W-6 UPPER SEGMENT: HWY 90 TO SW MILITARY DRIVE SEWER MAIN PROJECT

Solicitation Number: CO-00317

Job No.: 19-4519

ADDENDUM 1

DATE: FEBRUARY 2020	SAWS PROJECT NO. 19-4519	SHEET NO. C74
DESIGN: KFA	KHA PROJECT NO. 068665052	
DRAWN: KFA		
CHECKED: KFA

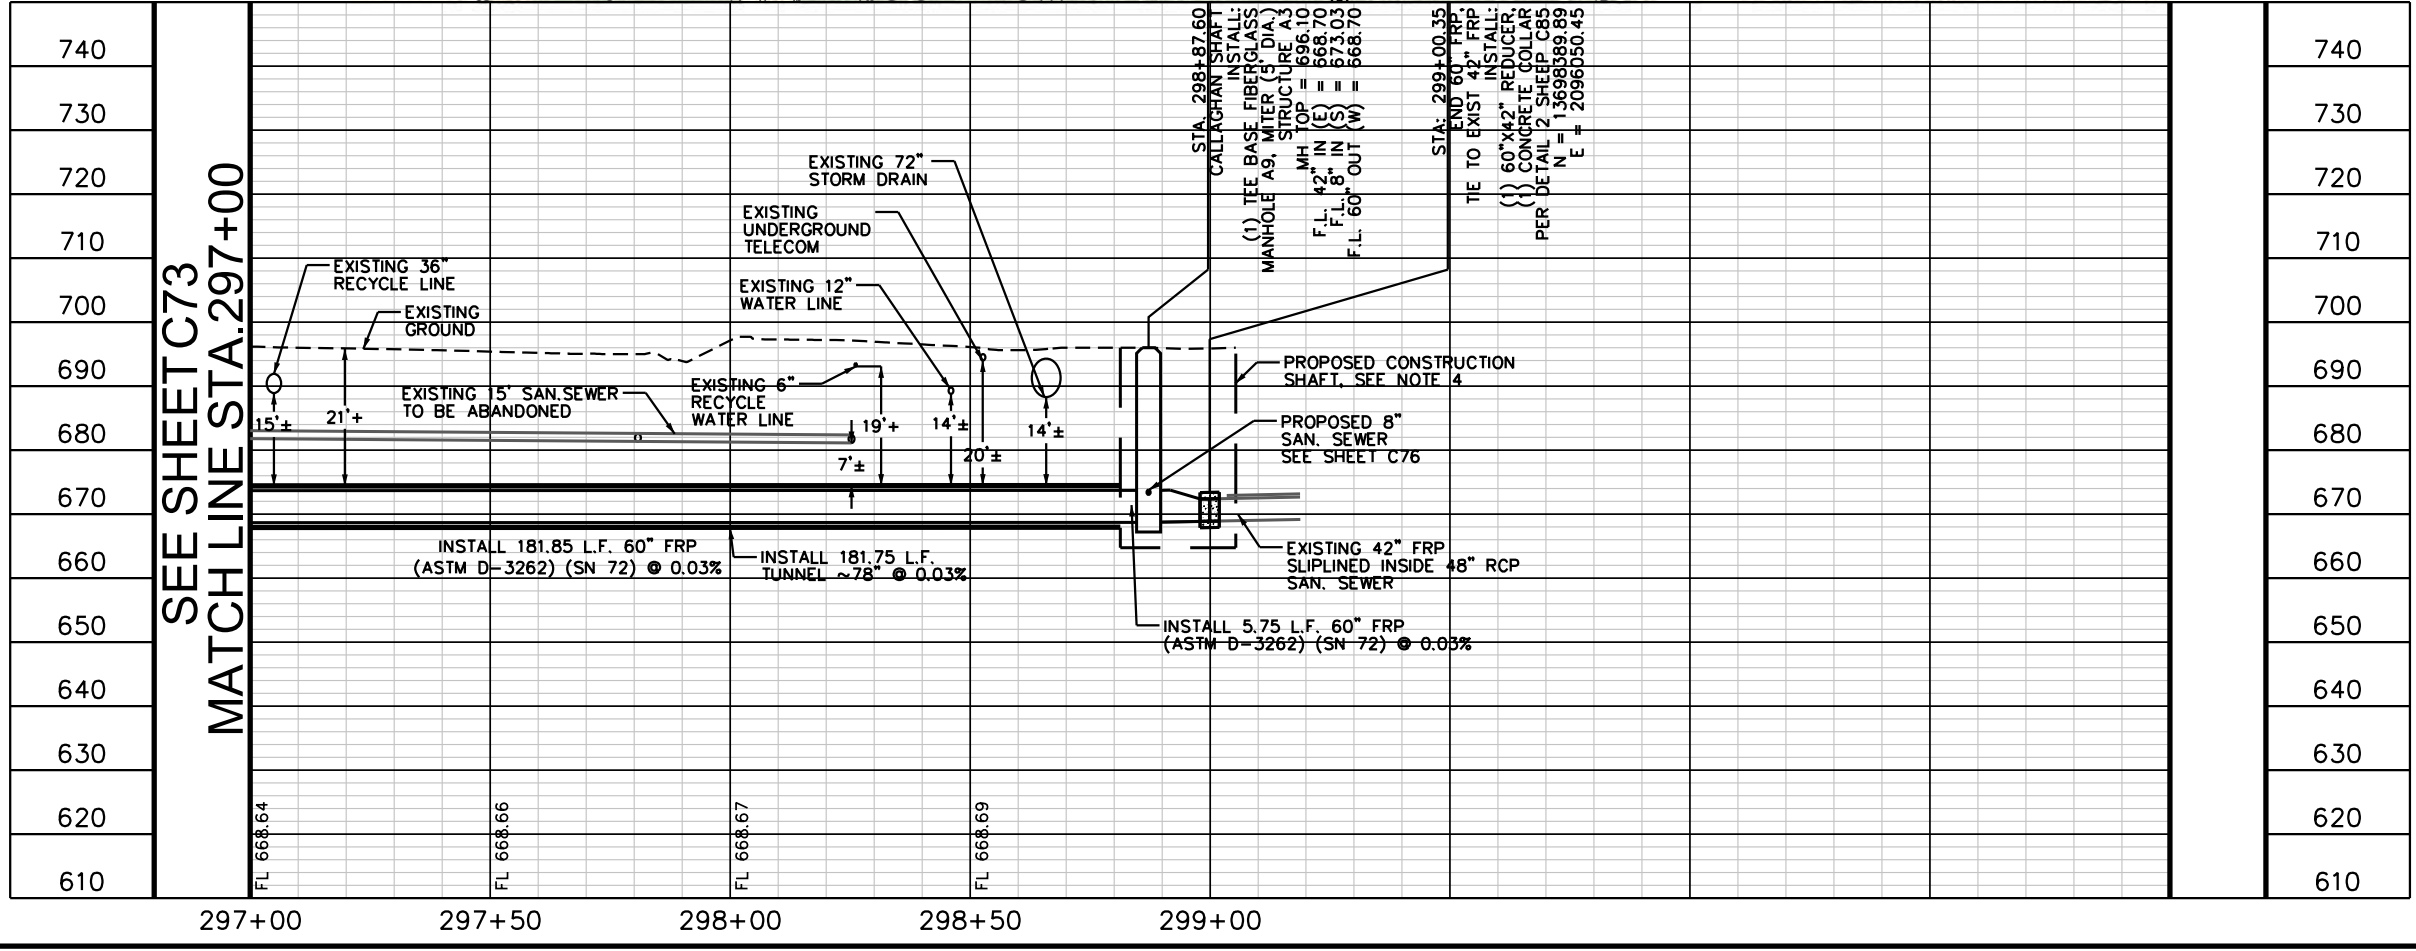
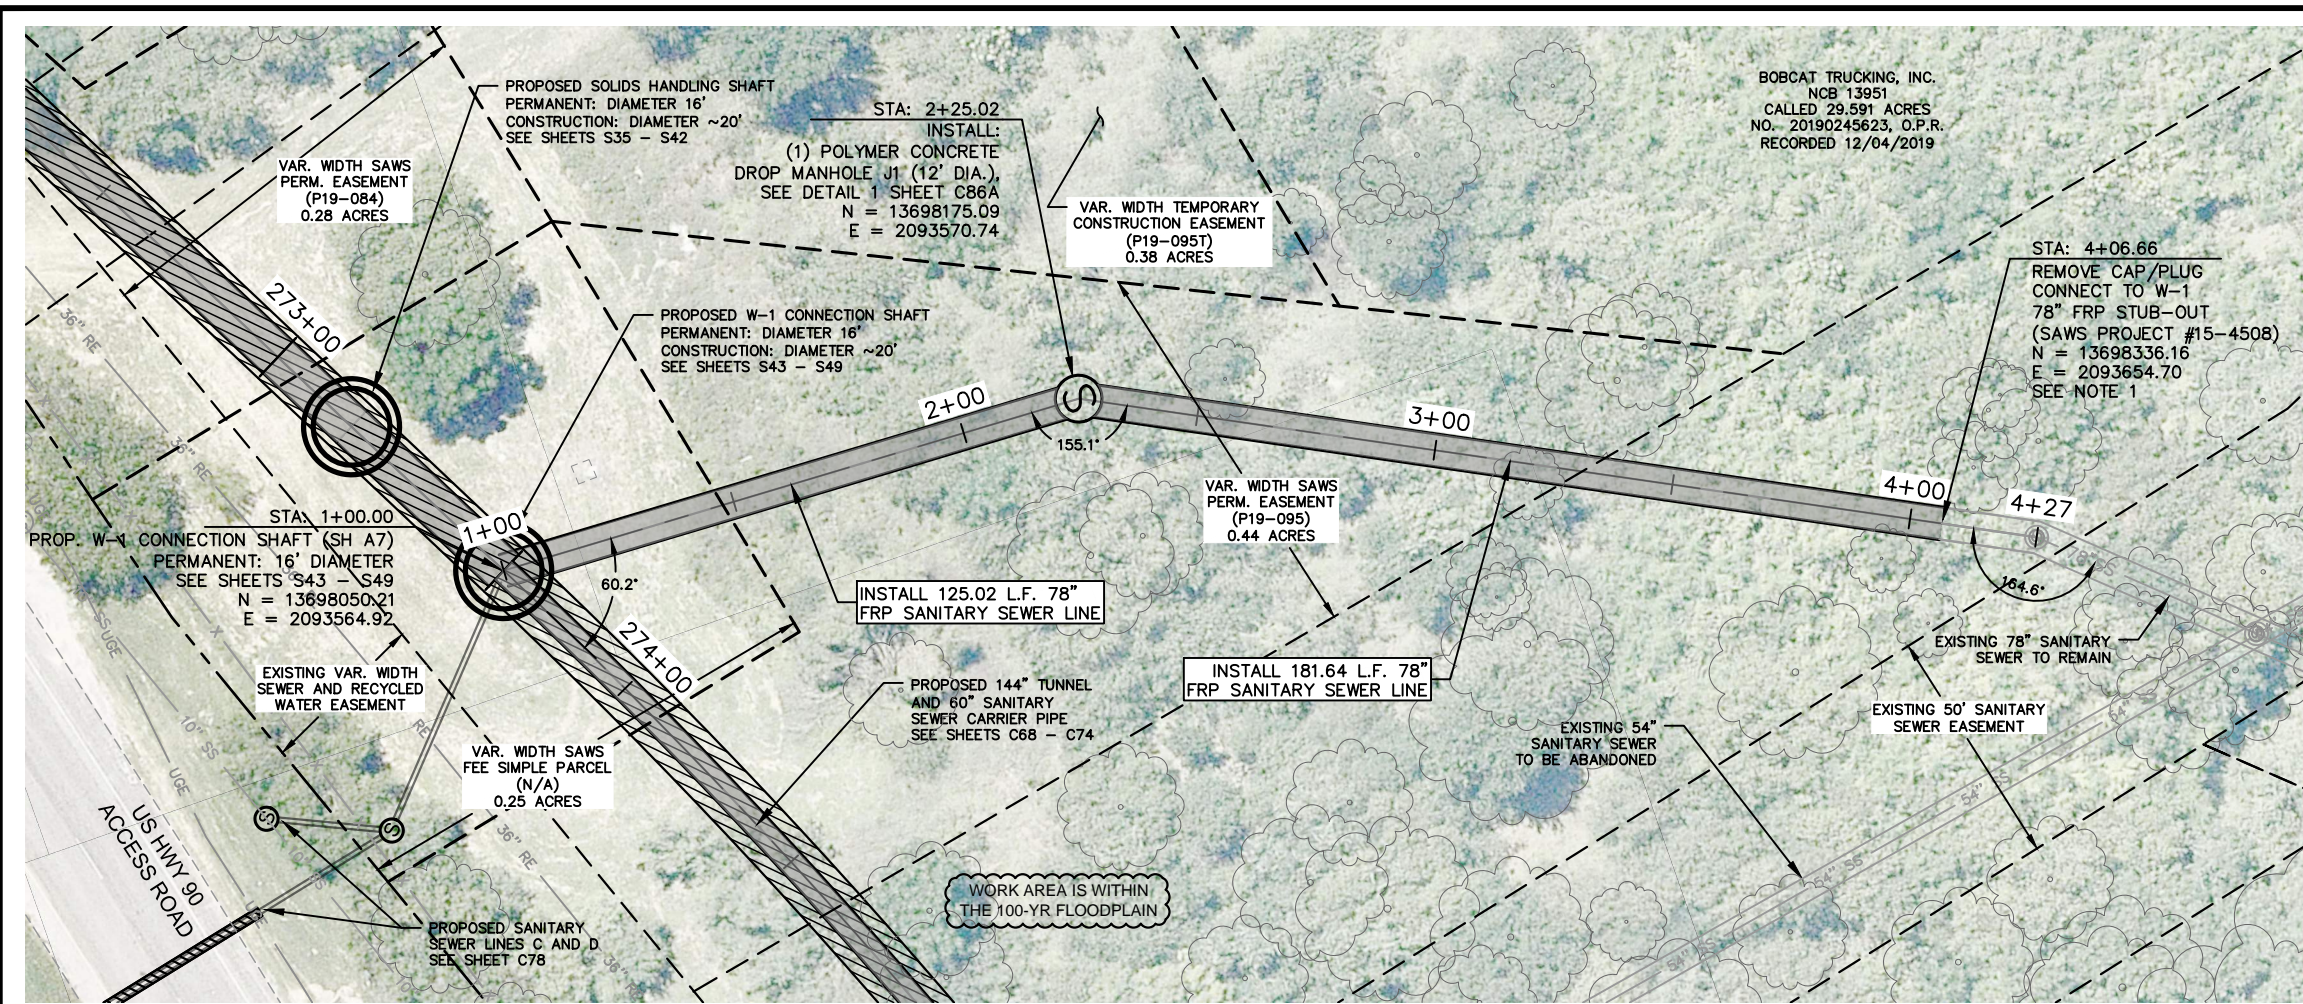
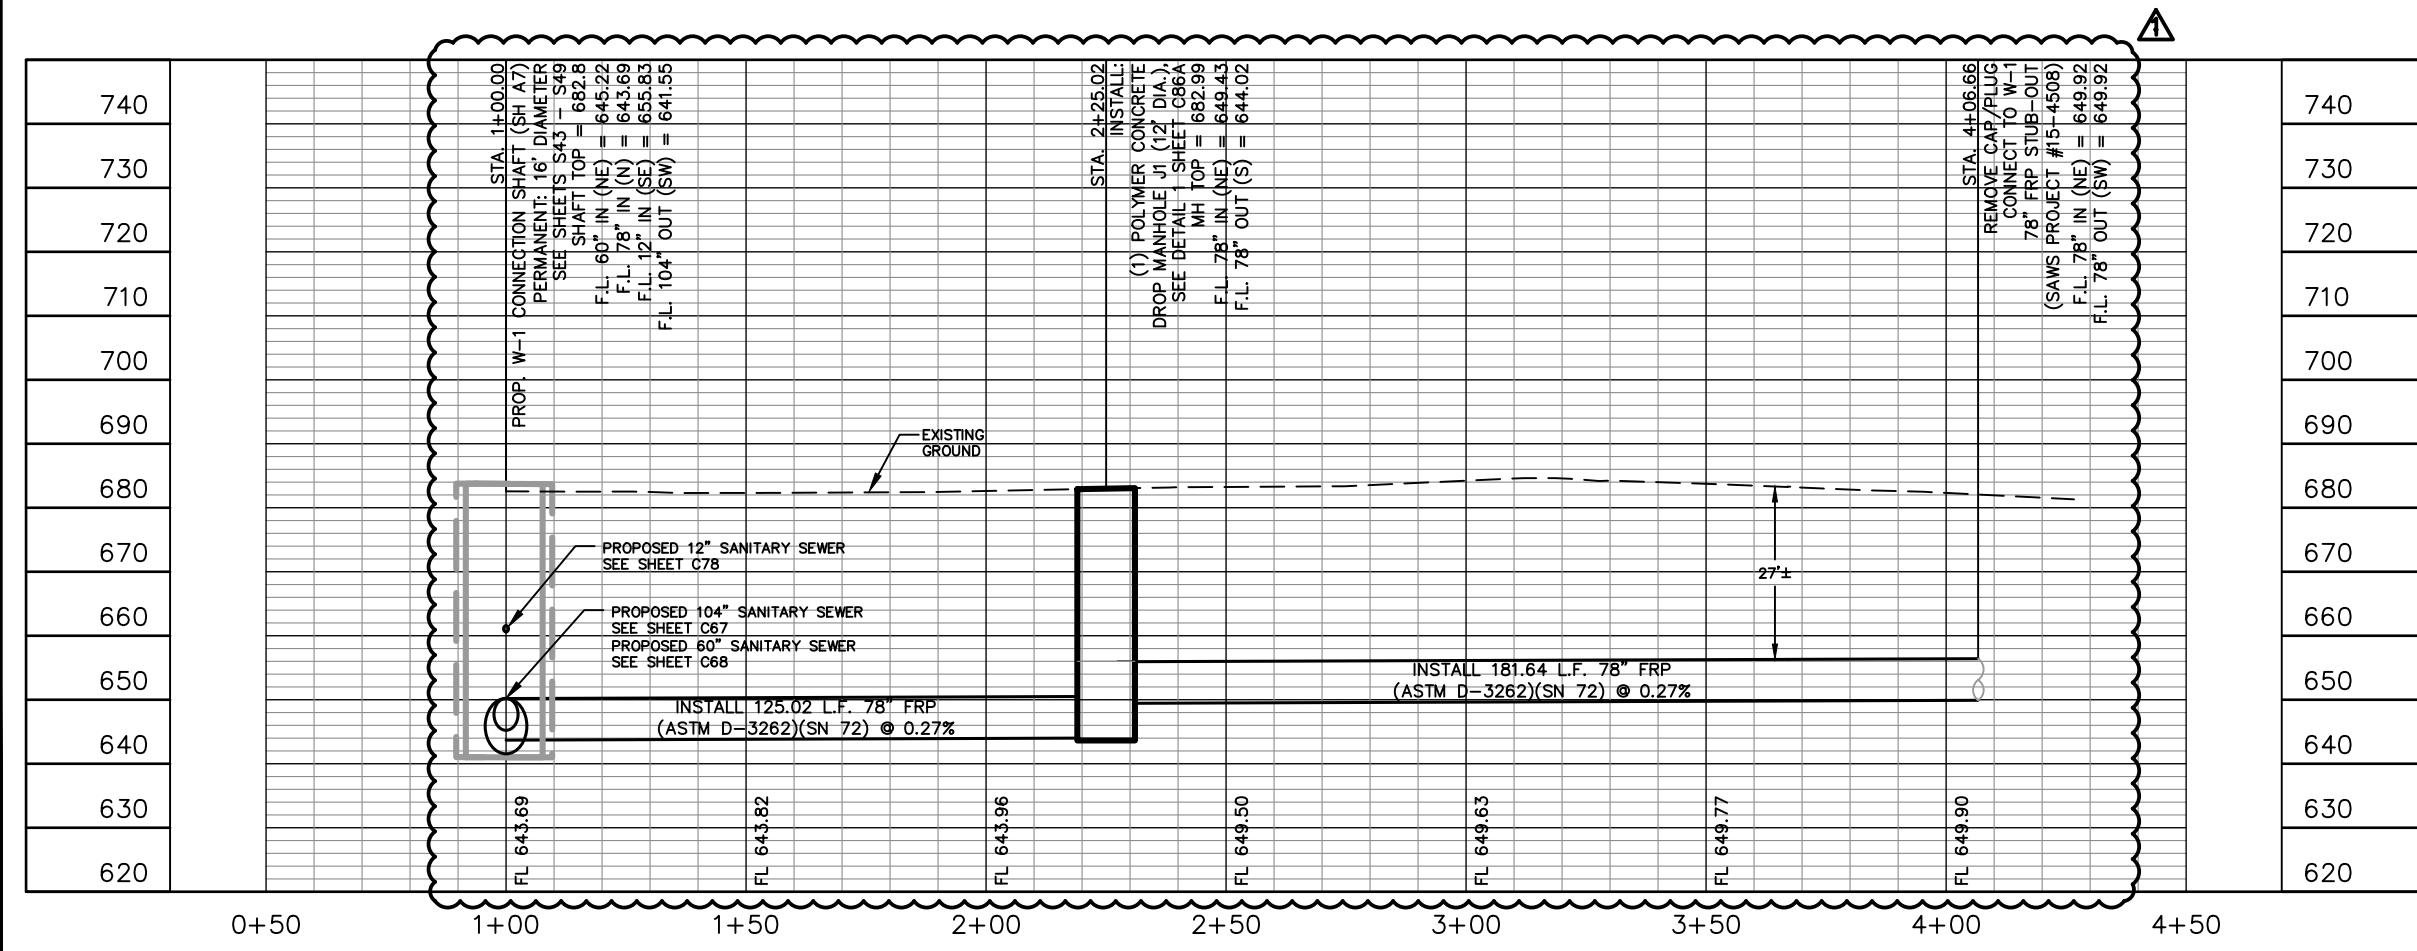
- Sheet C74- 60-INCH SANITARY SEWER PLAN & PROFILE - Revise and replace sheet in its entirety
 - Quantity for line item 857A 60-inch FRP (ASTM D-3262) (SN 72) Sanitary Sewer Line (25’-30’ Depth) “857A” with the following: “857”.

DATE:	SAWS PROJECT NO.	SHEET NO.
FEBRUARY 2020	19-4519	C80
DESIGN: KFA	KHA PROJECT NO.	
DRAWN: KFA	068665052	
CHECKED: KFA

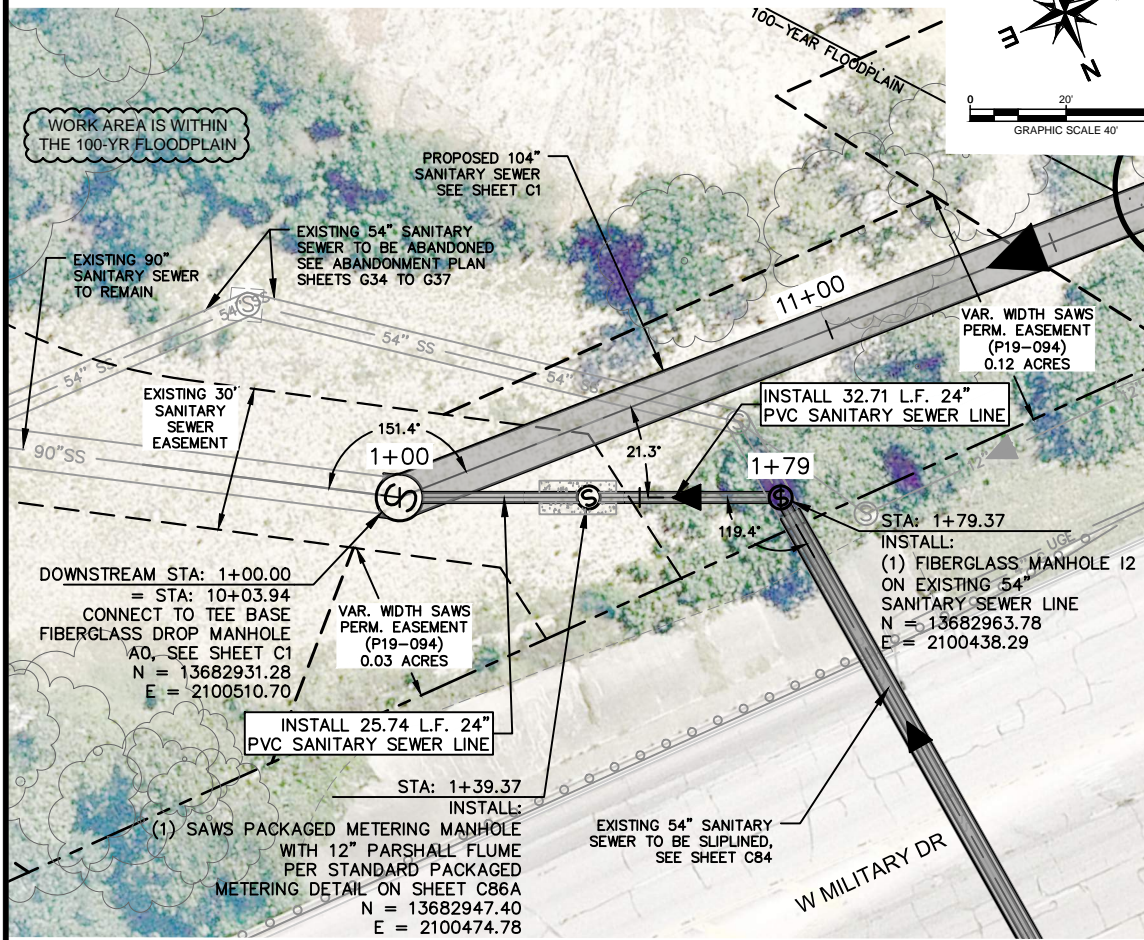
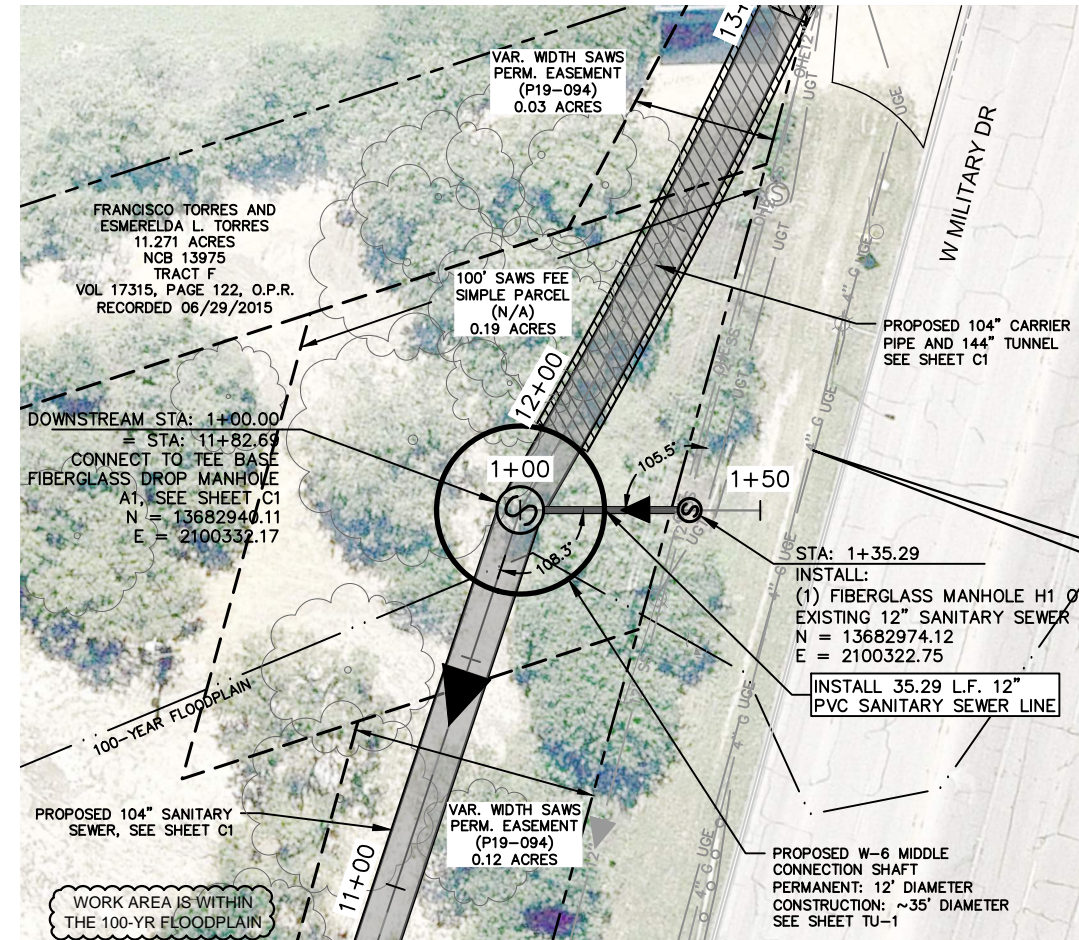
- Sheet C80 – 15-INCH SANITARY SEWER PLAN & PROFILE LINE E - Revise and replace sheet in its entirety
 - Label of shaft top rim elevation for Prop. Ballpark Shaft (SH A8)- “SHAFT TOP = 701.13” with the following: “SHAFT TOP = 701.24”.

DATE: MARCH 2020	SAWS PROJECT NO. 19-4519	SHEET NO. C83
DESIGN: JKN	KHA PROJECT NO. 068665052	
DRAWN: CRW		
CHECKED: JAF

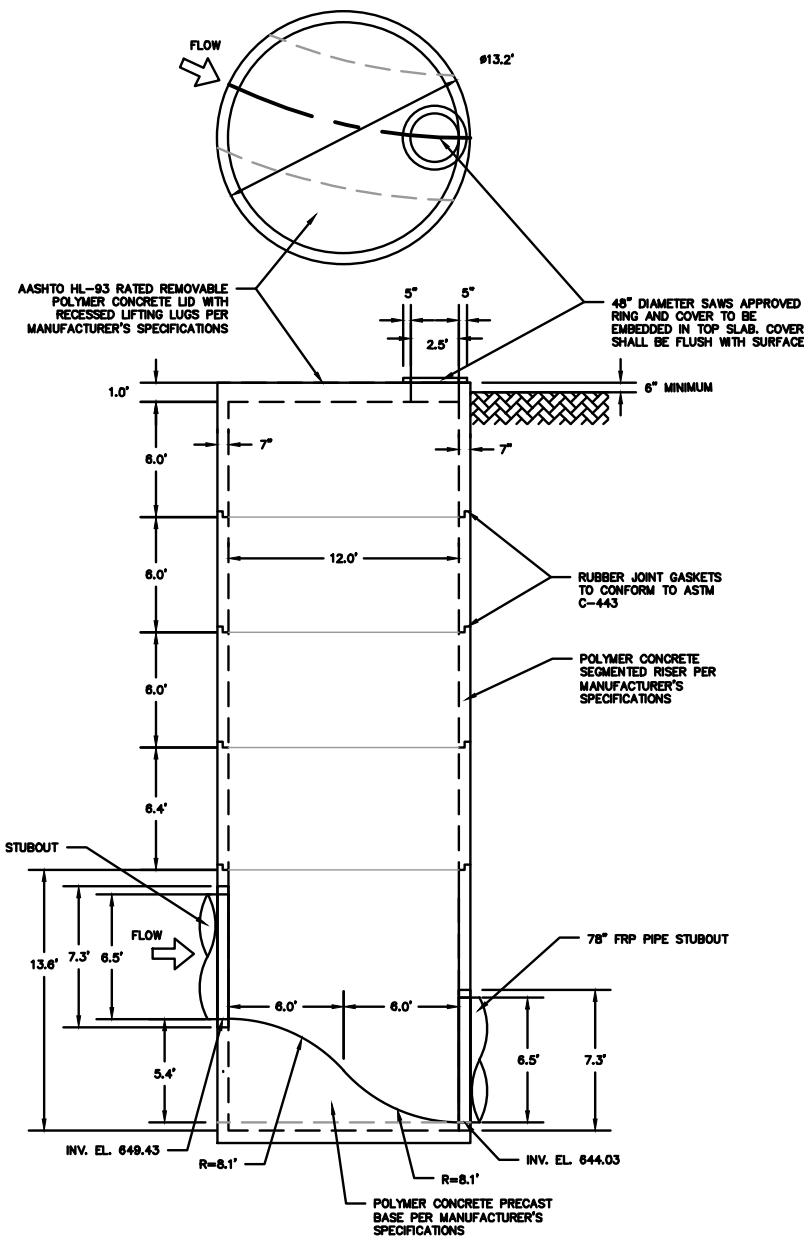
- Sheet C83 – SANITARY SEWER PLAN & PROFILE LINE H AND LINE I - Revise and replace sheet in its entirety
 - Label of manhole top rim elevation for Manhole A1 Miter - “MH TOP = 644.9” with the following: “MH TOP = 645.8”
